**Remediation Plan
Portac Log Sort Yard
Port of Tacoma, Washington**

**SEPTEMBER 14, 1988-ADDENDUM 1 TO EXHIBIT B
VOLUME I, REMEDIATION PLAN JUNE 17, 1988
PORTAC LOG SORT YARD
PORT OF TACOMA, WASHINGTON**

This document amends and adds to Volume I of the June 17, 1988 Remediation Plan for the Portac Log Sort Yard. This addendum together with Volumes I and Volume II of the Remediation Plan constitute Exhibit B. Additional material is divided into the following areas:

Figure 1

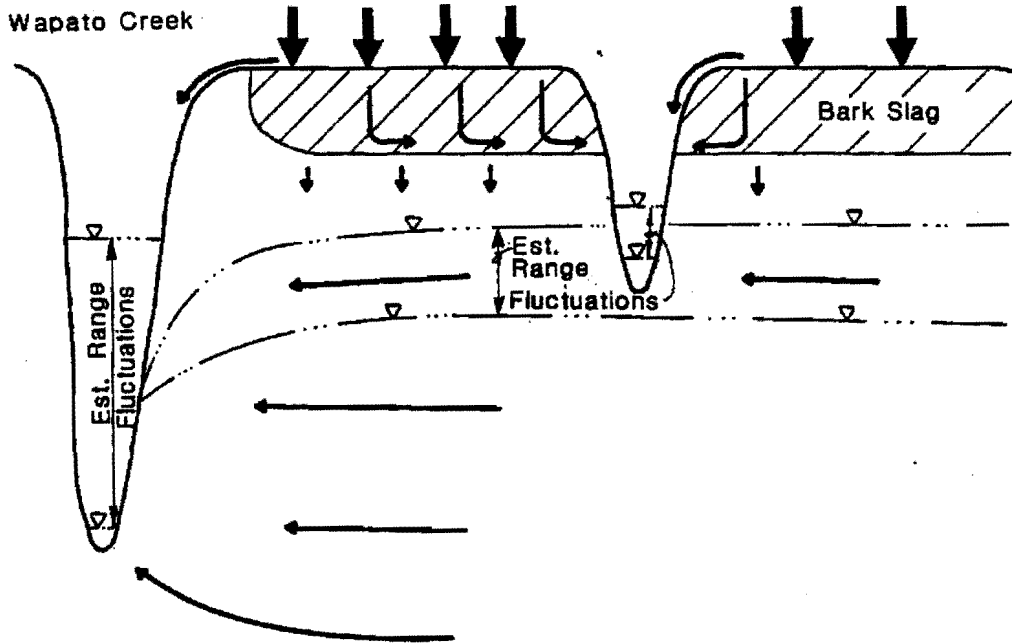
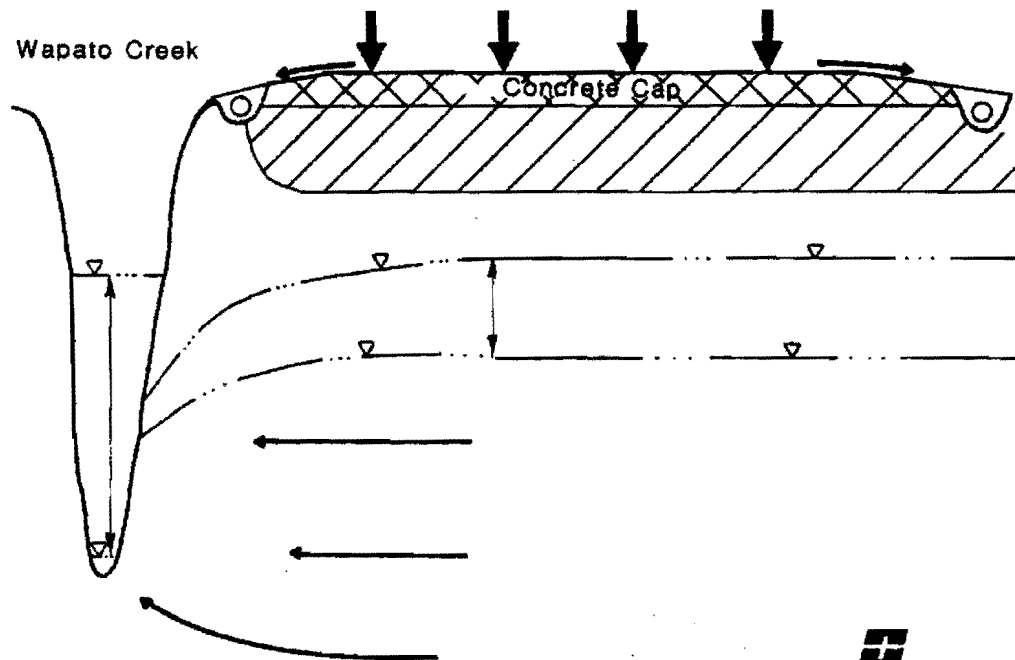
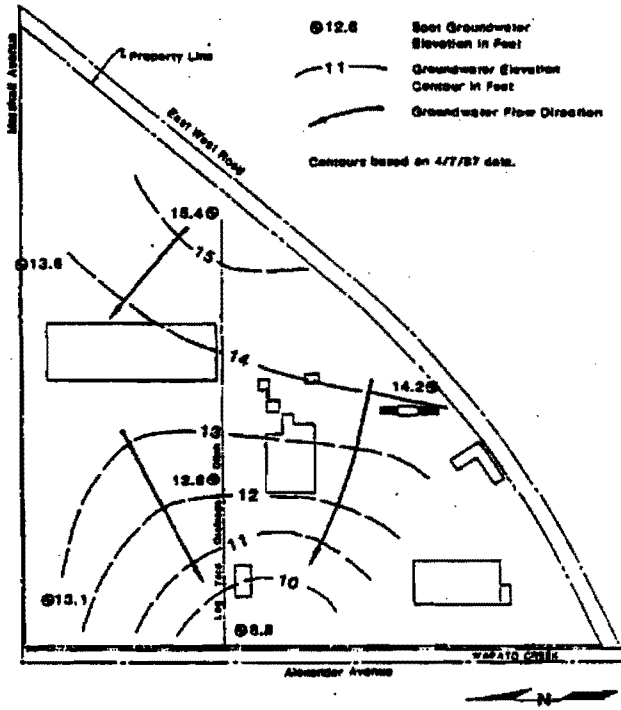
Surface water is defined as overland flow and shallow subsurface storm flow. Groundwater is considered to be saturated soils below the water table. Groundwater flow and surface water flow are the two potential pathways for metals migration from the site to Wapato Creek. Our observations from the site investigations indicate that precipitation falling on the Portac site either runs off the site and discharges to

surface water or slowly infiltrates to the water table. See Figure 1 attached.

Groundwater Elevation Contour Maps

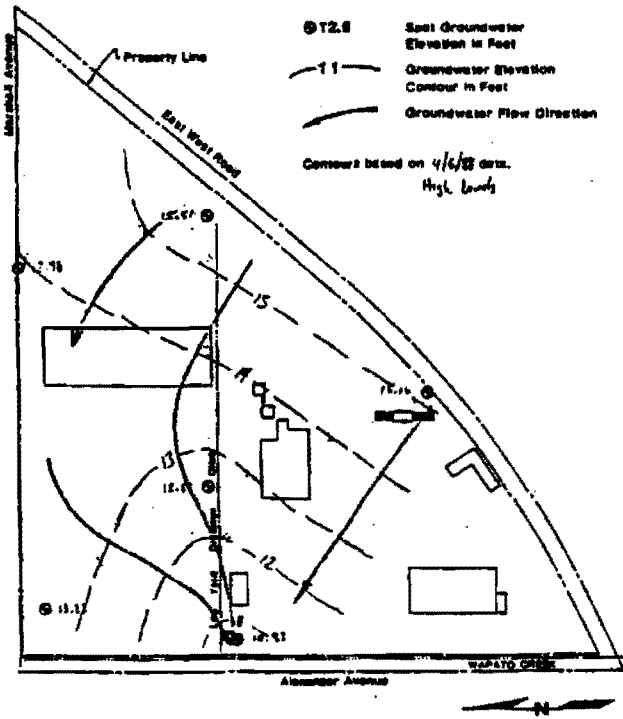
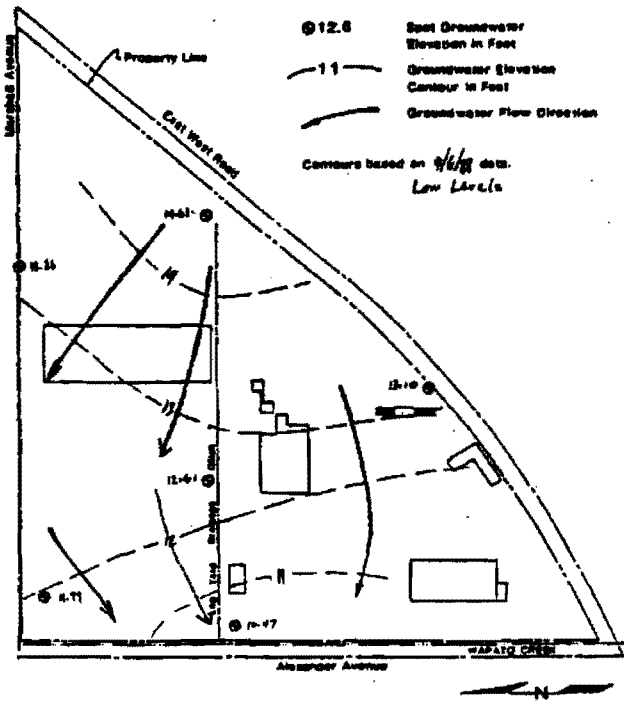
The water level fluctuations were used to assess whether the water levels will rise into the slag. Because the ground surface, slag occurrence, and groundwater levels vary across the site it was necessary to compare elevation data at various points across the site. Our analyses of the base of slag elevation and the water level elevation are presented in detail in Appendix F. Figure 3 (attached) presents a plan of the site showing the thickness of the unsaturated soil between the bottom of the slag and the water table using 4/87 data which is close to the high water level.

Based on our estimated maximum fluctuation of 4 to 5 feet and the reasonable assumption that the April 1987 data are close to the high level, it still appears unlikely that the groundwater level will rise into the slag. Even a 2-foot higher water level than the highest recorded to date

will leave at least 1 foot of unsaturated conditions between the bottom of the slag and the water table (as can be seen from Figure 3).

Groundwater discharge from the site is focused through a zone approximately 600 ft wide, located near well B-5 (See Groundwater Elevation Contour Maps).

Hart Crowser, Inc.
J-1773-04 9/88
Figure 3

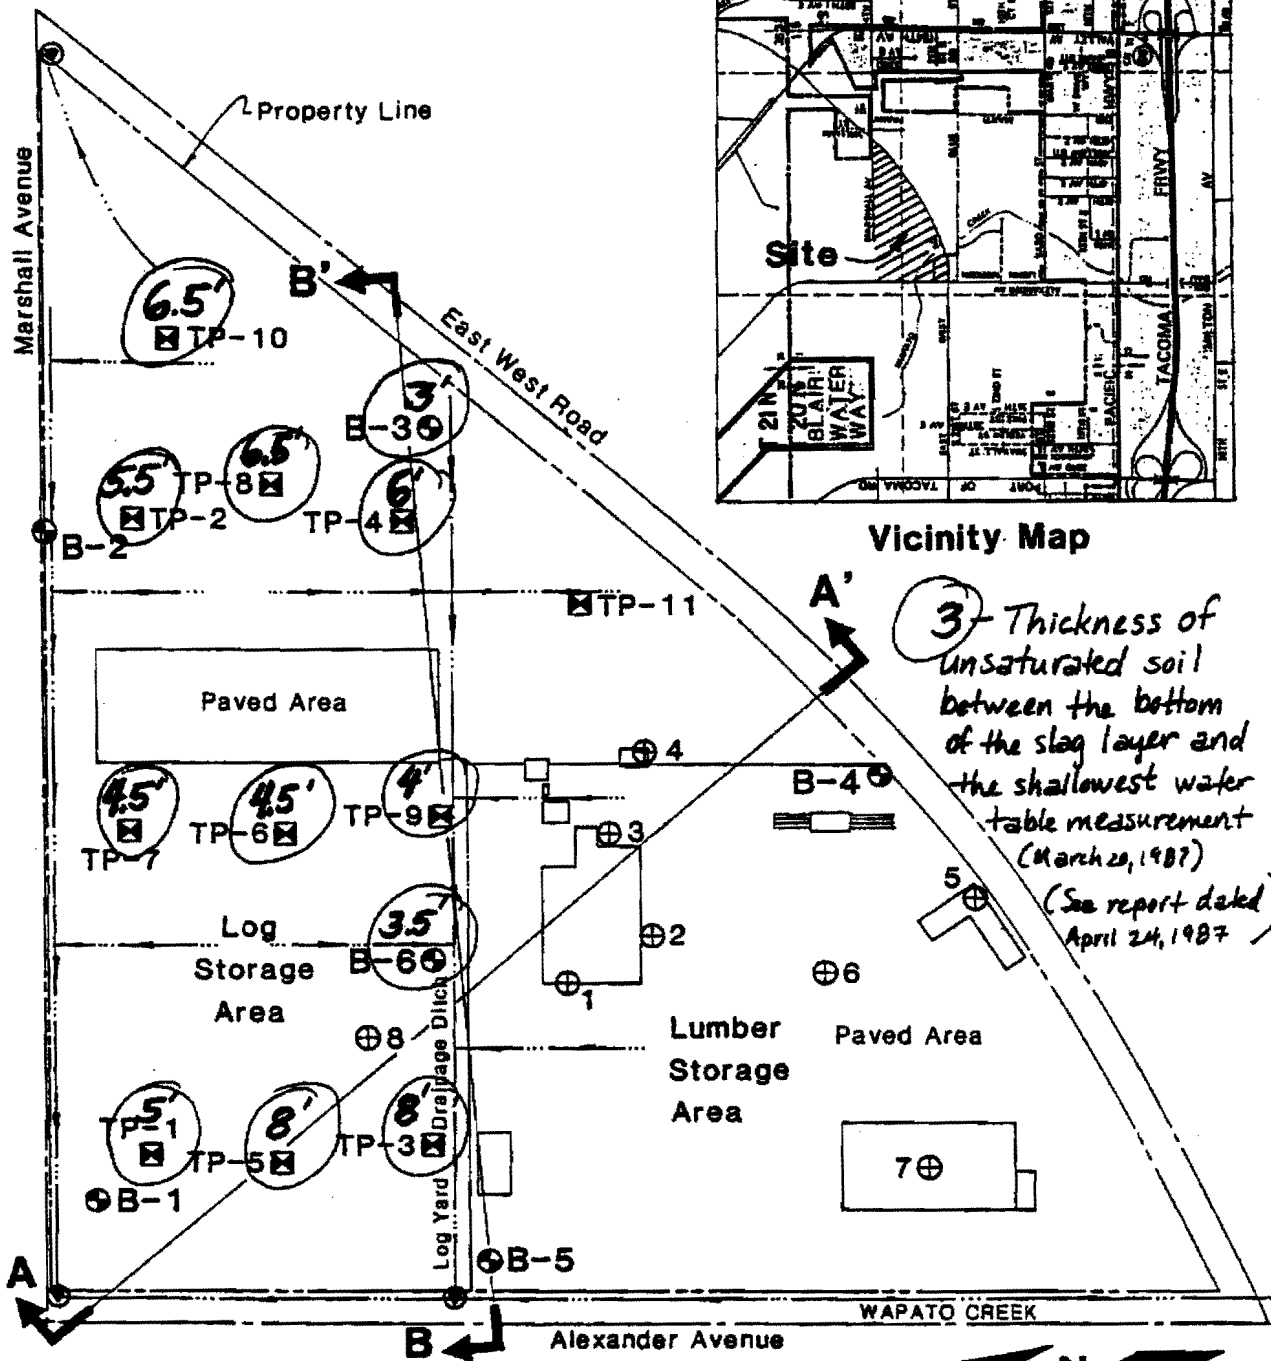
In addition to the existing wells we will install two shallow wells to the bottom of the slag layer (just above the interface of the slag and underlying silt) to verify our assessment that groundwater does not occur within this layer. These wells will be located in the vicinity of the existing B-1 and B-3.
